Hinkley Point C

Expert Statement to the EIA

REPORT
REP-0413

Figure 1: Time Line Post Accident Management (SBO at Power States)

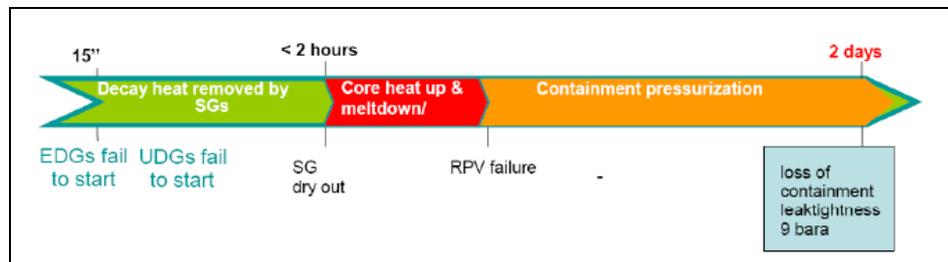
According to the Stress Tests for Olkiluoto 3, in case of SBO, if countermeasures were unsuccessful, the uncovering of the core would take place within 3 hours with extensive fuel damage within 4 hours and pressure vessel melt-through within 7 to 8 hours after an accident starts (ENSREG 2012).

Figure 1 illustrates the resulting Time Line for Post Accident Management (SBO = Total Loss of AC Power for Power States) (UK EPR 2011, 16.6).

Figure 2: Caesium-137 deposition after a severe accident at Hinkley Point B

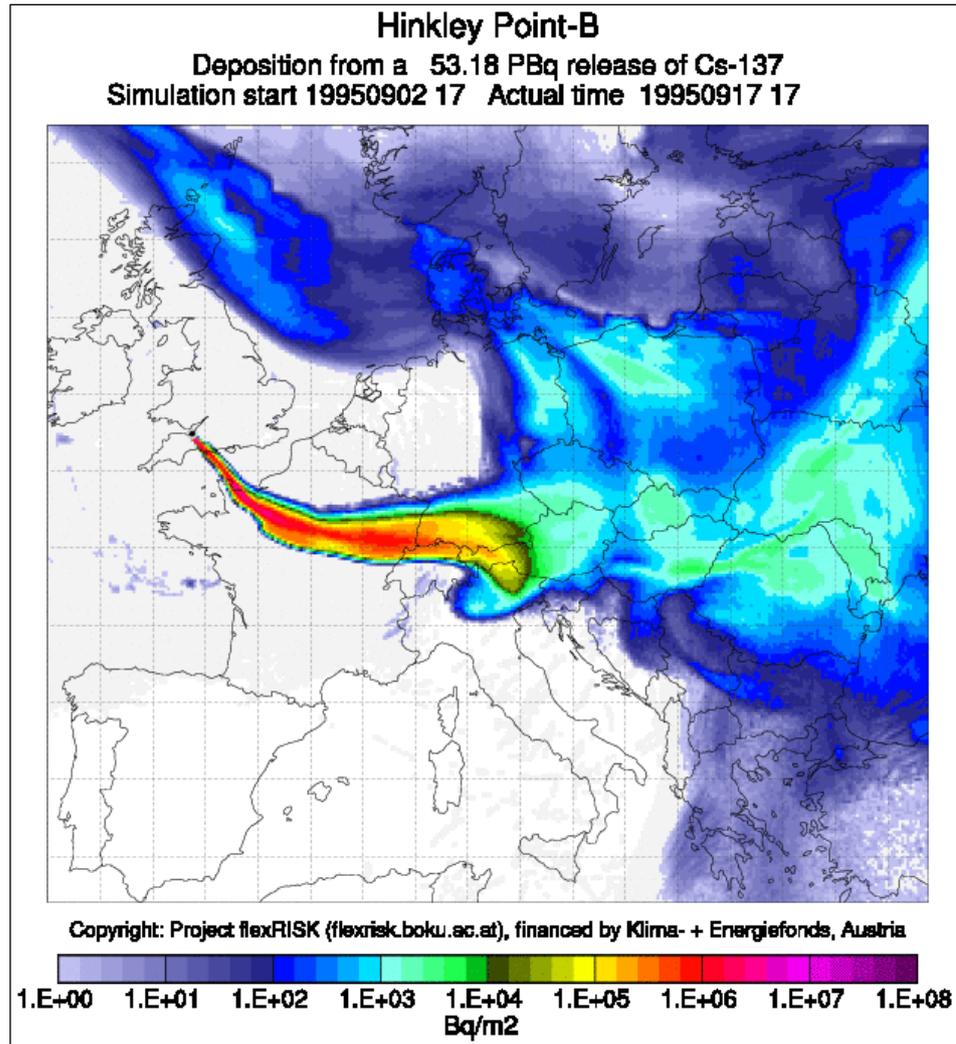
Figure 2 illustrates the calculated caesium-137 depositions after a possible severe accident at Hinkley Point B (FLEXRISK 2012a).

For a potential caesium-137 release of 53.18 PBq at Hinkley Point NPP under conditions comparable with those on September 2, 1995, a considerable contamination of the Austrian territory would result. Most parts show depositions of about 1E+03 Bq/m². However, in some areas the values are between 1E+04 and 1E+05 Bq/m², even up to 2E+05 Bq/m².

If a contamination of ground (and air) beyond certain thresholds can be expected, a set of agricultural intervention measures is triggered. These measures include earlier harvesting, closing of greenhouses and covering of plants, putting livestock in stables etc. For these measures, Austrian and German authorities defined a threshold for caesium-137 ground deposition of 650 Bq/m² (SkkM 2010; Ssk 2008). These agricultural measures are quite complex and take some time. Reactions are especially difficult if there is only very little time between the onset of an accident and the arrival of the first radioactive clouds (FLEXRISK 2013b). For the calculated scenario, ground depositions of all areas are higher than this threshold, i.e. Austria would be highly affected.

Figure 2 shows that Austria and many other countries (including Germany and Switzerland) could be affected by a severe accident at Hinkley Point C.
